Central Park MPD Tract B

Schedule of Deviations and Justifications

ADD2024-00029 – Revised April 2024

SECTION J-J
NTS

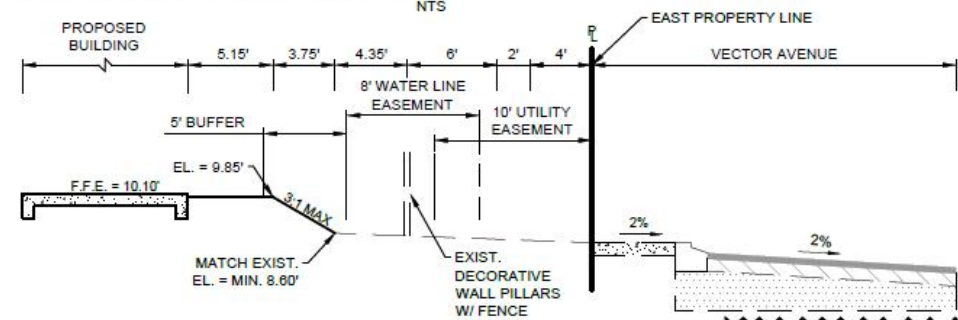
NEW Deviation 7: LDC Section 10-421(a)(8) requirement that if a wall or fence is proposed, but not required, then the required buffer plantings must be installed on the exterior side (between the wall and the abutting property or street right-of-way) of the wall or fence; to allow the required vegetation to be installed behind the existing decorative fence on Vector Avenue for Tract B.

Justification: This deviation is requested due to the location of the existing decorative wall pillars and fence that was previously installed on the site and the existing utility easements along Vector Avenue. There is an existing 10-foot utility easement along the entire frontage and an existing 8-foot waterline easement along the northern half of the frontage. The existing fence lies within the 8-foot waterline easement and just behind the 10-foot utility easement leaving no room for the buffer trees to be planted in front of the decorative fence. The Mixed Use Overlay requires 5 trees per 100 linear feet (total of 10 trees). The fence is an architectural embellishment that was installed as part of the prior commercial development proposed on the site and is not a residential project fence or wall. There is one carport where the 5-foot buffer encroaches slightly within the existing easements; however no trees will be planted in this area. Please see cross-sections, excerpt from proposed landscape plan, and picture showing existing fence, trees and overhead power lines on the following page. There are existing trees located along this area of the project. To keep the exiting trees as required in their current location is not recommended and not a professional Best Management Practice due to the growth habit of a Live Oak in close proximity to overhead power lines. The existing trees will likely result in poor pruning practices and potential power supply and distribution issues if the trees remain. Should any of the existing trees require removal and qualify as a heritage tree, they will be mitigated on site away from overhead powerlines. The requested deviation enhances the achievement of the objectives of the planned development and will protect the public health, safety and welfare.

*NO BUFFER TREES TO BE PLANTED IN EASEMENT
